ADDENDUM #3

A New Transylvania County EMS Base, Brevard, North Carolina

October 14, 2022

This addendum supersedes all other addenda and forms a part of the bid documents and modifies the original project manual and drawings dated September 21, 2022.

1 FLOOR PLAN - HVAC
 M1.1 SCALE: 1/8" = 1'-0"

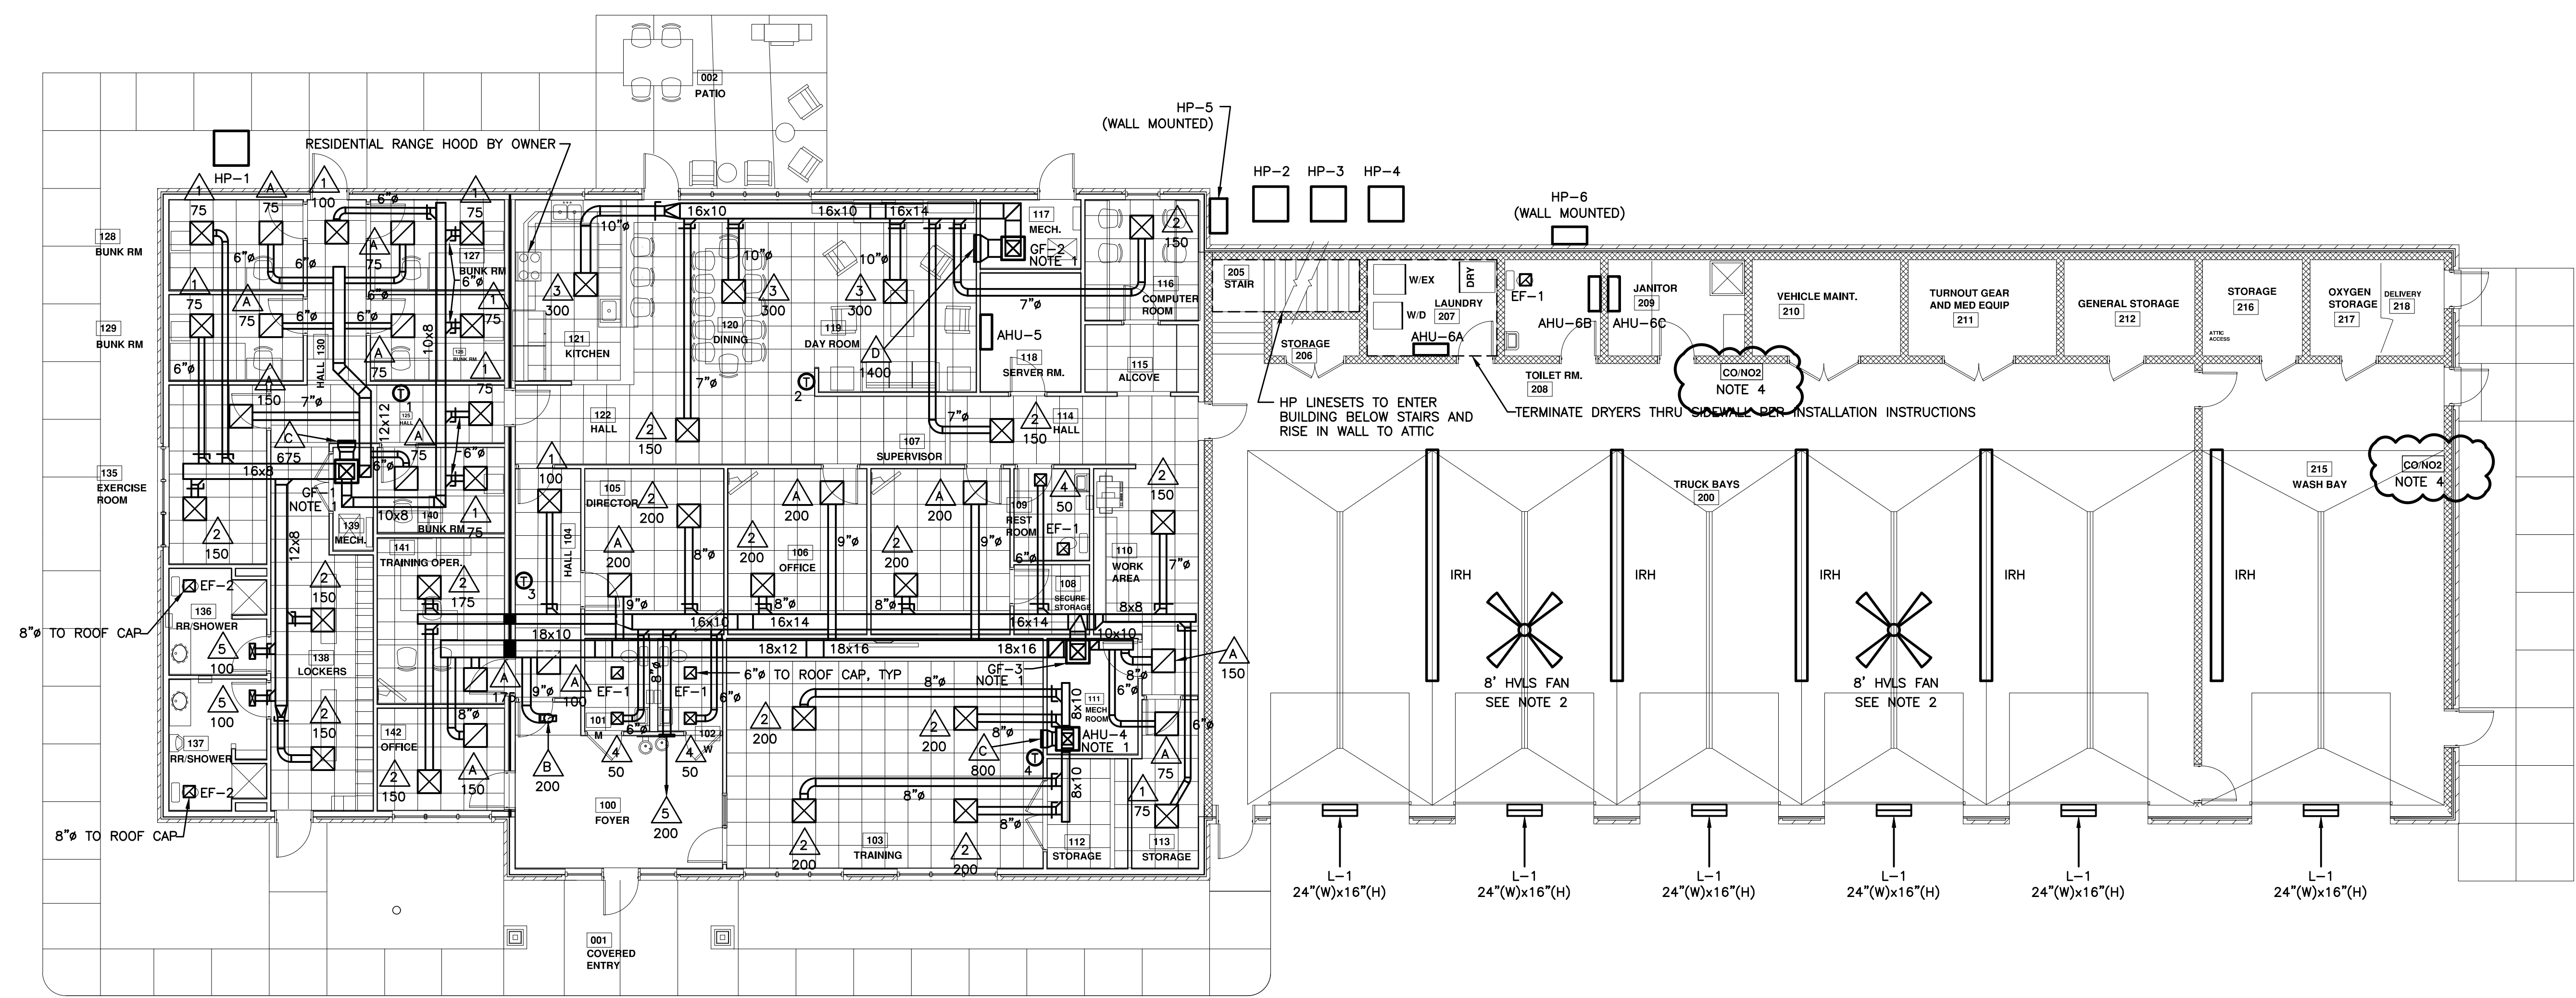
- NOTES:
- PROVIDE 10" FRESH AIR DUCT FROM SOFFIT VENT TO AHU OR GF. VERIFY EXACT LOCATION OF SOFFIT VENT AND DUCT ROUTING WITH OWNER, ARCHITECT, AND ENGINEER PRIOR TO INSTALLATION.
 - BASIS OF DESIGN FOR HVLS FAN & CONTROLS:
 SKYBLADE "SHOP PROP" #SP-0824-512-1 (1.35 HP, 5.2A, 120V, 1 PHASE) WITH SINGLE YOKE CONTROLLER #DP-779
 - CO/NO2 DETECTOR BASIS OF DESIGN: BACHARACH MODEL #MGS-550
 DETECTOR INSTALLED IN TRUCK BAY SHALL CONTROL EF-3
 DETECTOR INSTALLED IN WASH BAY SHALL CONTROL EF-4
 EACH FAN SHALL ALSO HAVE MANUAL CONTROLS.
 DETECTOR PROVIDED BY MC, WIRED BY EC

1 FLOOR PLAN - LIGHTING
 E1.1 SCALE: 1/8" = 1'-0"

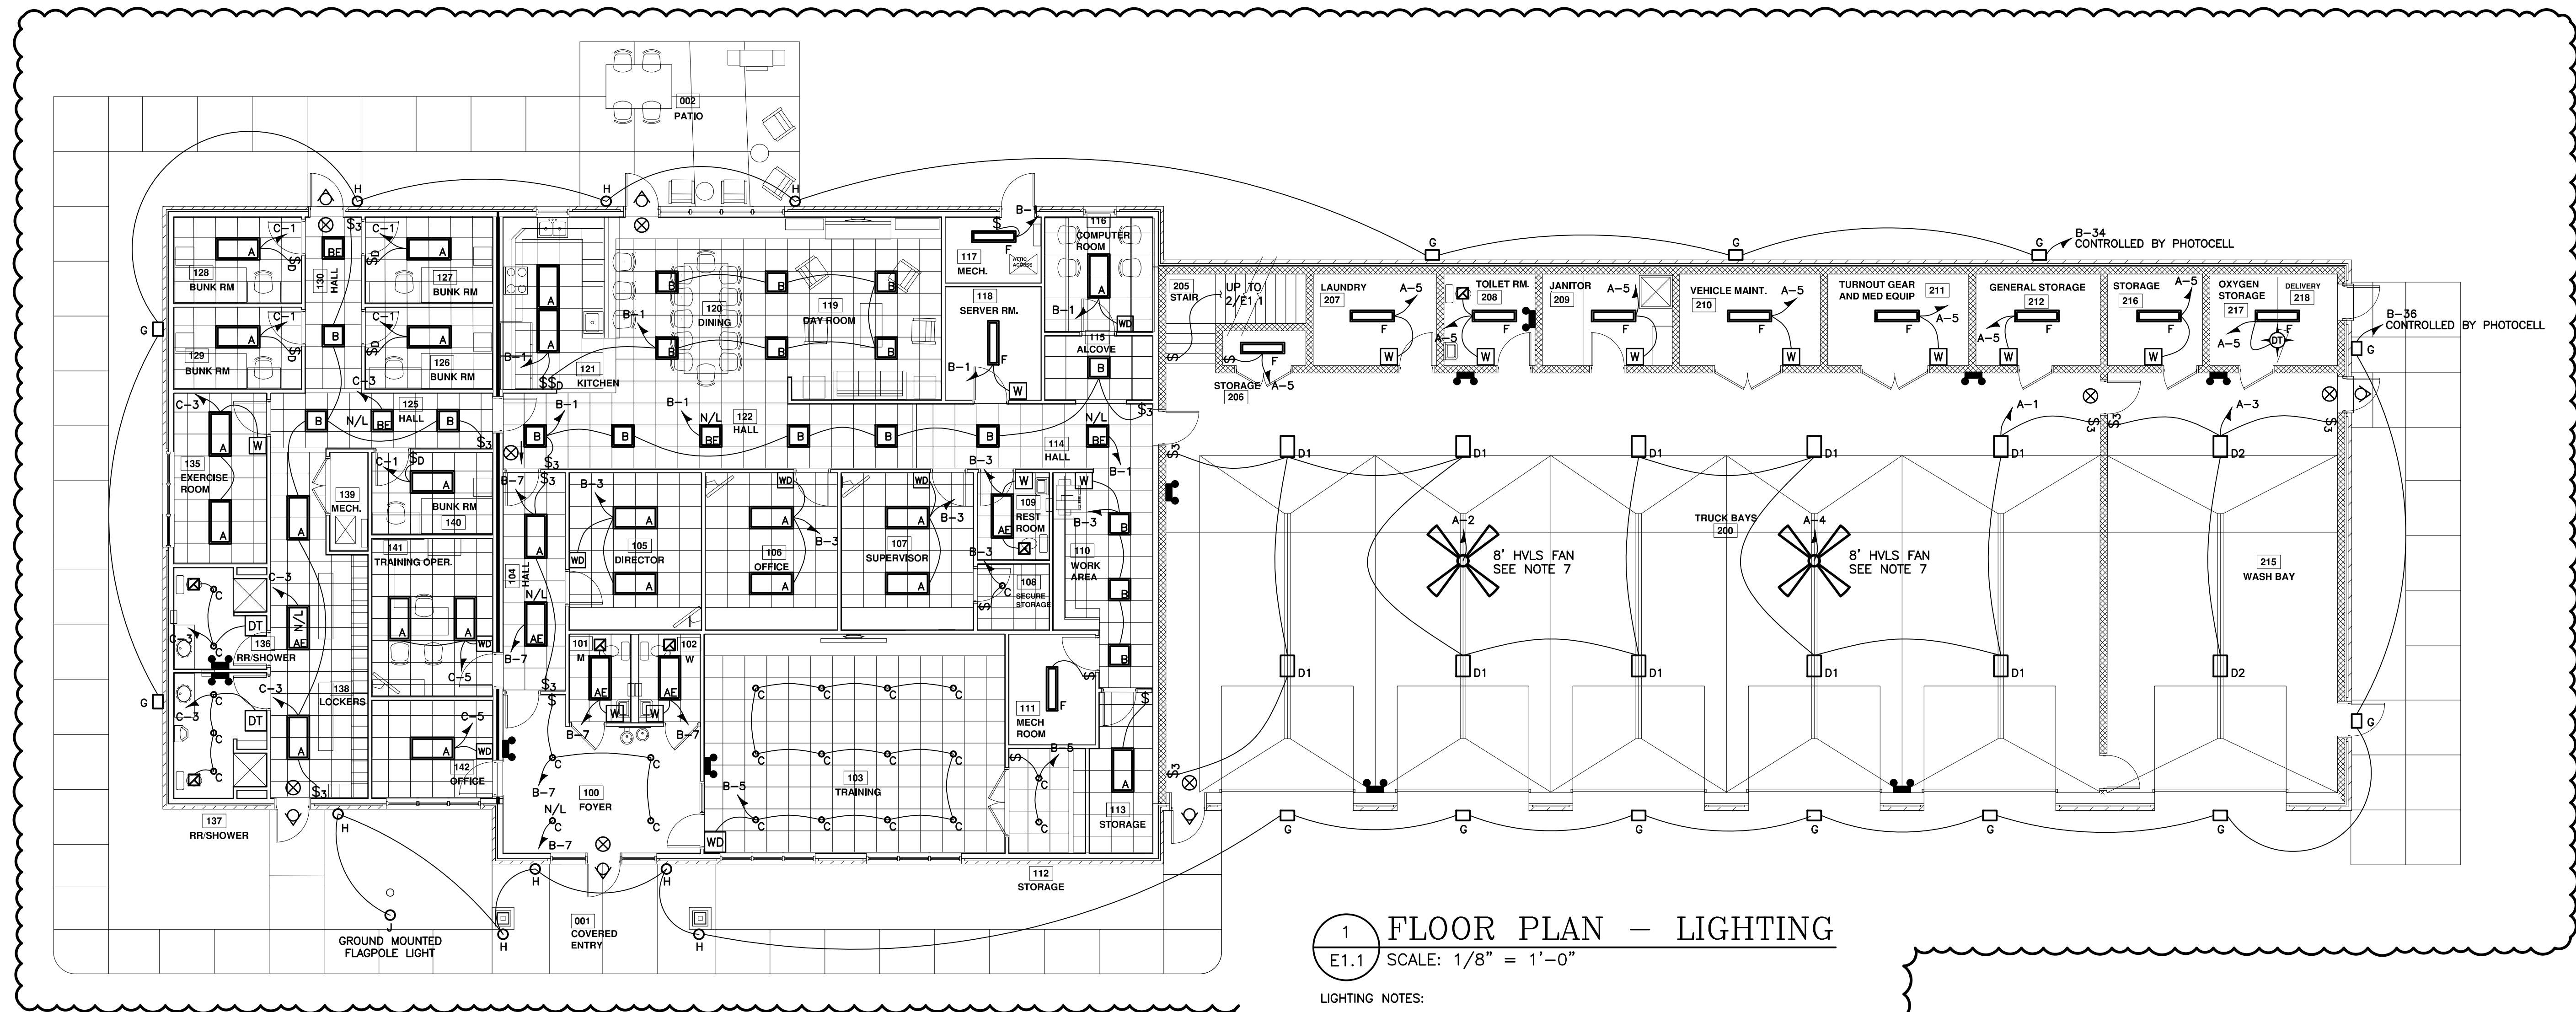
Attached you will find the Electrical Drawing Set sheets E1.1, E1.2, E1.3, E1.5, E2.1 and E2.2 that have been reissued in this addendum. The drawings have been marked with cloud designations indicating revisions that have been made.
